**U.S. Environmental Protection Agency
Region 2**

RESPONSE TO PUBLIC COMMENTS

OUTER CONTINENTAL SHELF AIR PERMIT

**Atlantic Shores Offshore Wind Project 1, LLC
Atlantic Shores Project 1 and Project 2**

Figure 1

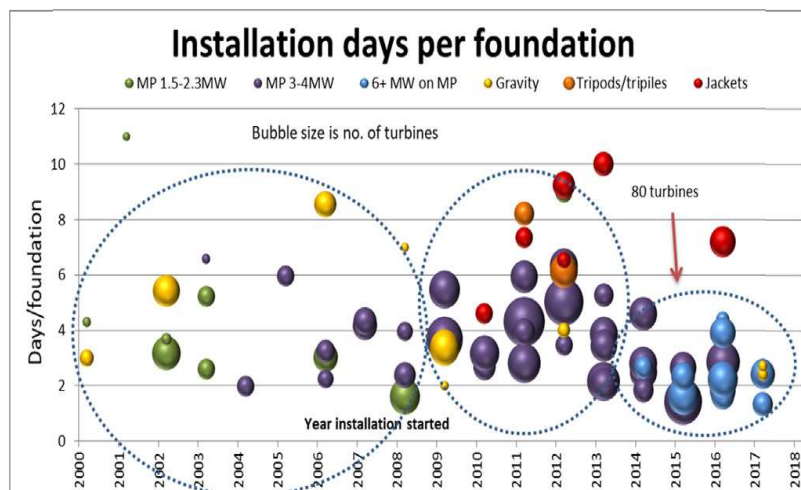
The Epsilon Associates estimate of 2.6 days for foundation installation is supported by real world experience with installation times as shown below.

On March 29, 2023, Atlantic Shores submitted updated information regarding the estimated days of construction for the foundation installation and WTG installation. Based on this submittal, foundation installation is expected to take 1.5 days per foundation, and WTG installation is expected to take 2.6 days per WTG. This distinction is important, as pile driving is associated with the foundation installation. *See* Response 5.4 for a more detailed discussion of foundation installation schedule.

In response to this comment, EPA sought supplemental information from Atlantic Shores, and Atlantic Shores reiterated that 1.5 days per foundation is the best estimate and the 2.6 days per foundation is not reflective of their best estimate. Atlantic Shores provided a real-world example with a similar value for a similar project, although it noted that foundation installation times can be variable. The Coastal Virginia Offshore Wind Project (CVOW), which is currently under construction off the coast of Virginia with similar monopile and transition piece foundations, has made announcements indicating that they started foundation installation on May 22, 2024, and had installed their 50th turbine on August 12, 2024, which is a pace of about 1.65 foundations per

Figure 2-2: Visibility Metrics levels at Brigantine Wilderness Area

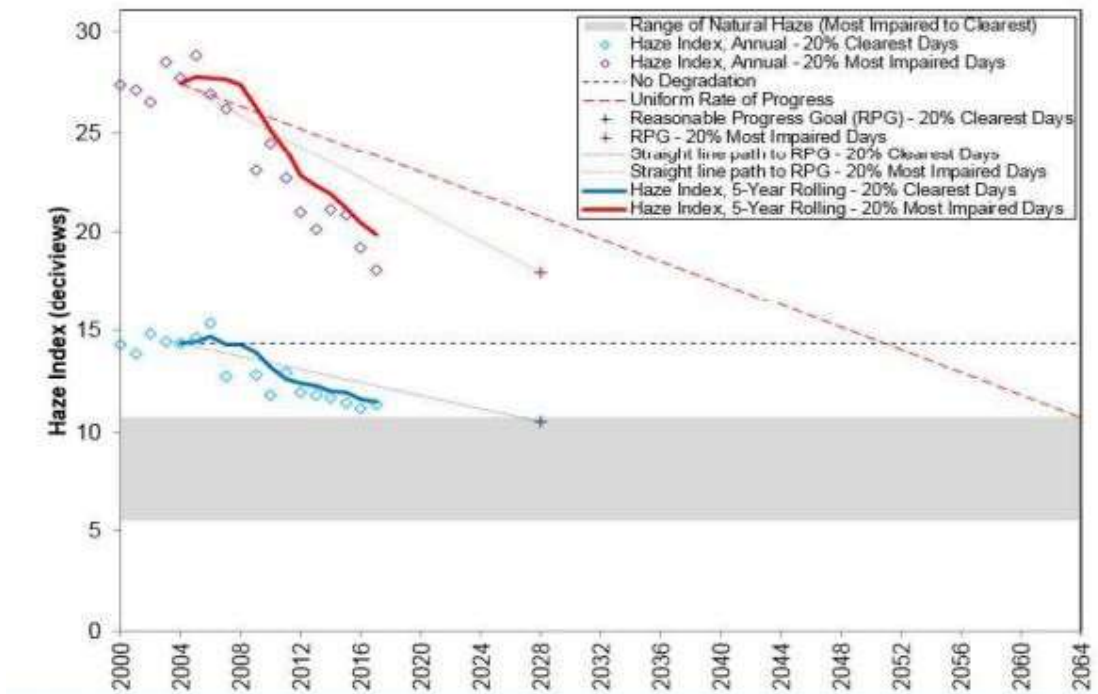
- s) Figure 2-2 of the New Jersey Regional Haze SIP shows that the projected 2028 visibility at the Brigantine Wilderness Area is well below the URP level. Additionally, the figure indicates that the observed 2016 visibility at Brigantine is approximately 6 deciviews below the URP glide path. The average observed visibility from 2018-2022 (see figure below) shows more than 6 deciviews below the URP glide path. Therefore, any potential increases in visibility degradation at Brigantine due to the project would not endanger Brigantine's visibility remaining below the URP glide path and meeting the regional haze rule goals.

The uniform rate of progress (URP) defines, in deciviews per year, the rate of visibility improvement that would be maintained to attain natural visibility conditions by the end of 2064. The URP or glide path is represented in Figure 2-2 as a straight line between baseline conditions and 2064. DEP's calculations using most impaired days show the URP to be 0.28 deciviews per year. See Table 2-3. As seen in Figure 2-2, the reasonable progress goals established for 2028 at the Brigantine Wilderness Area are expected to provide visibility improvements at a greater rate than this rate.
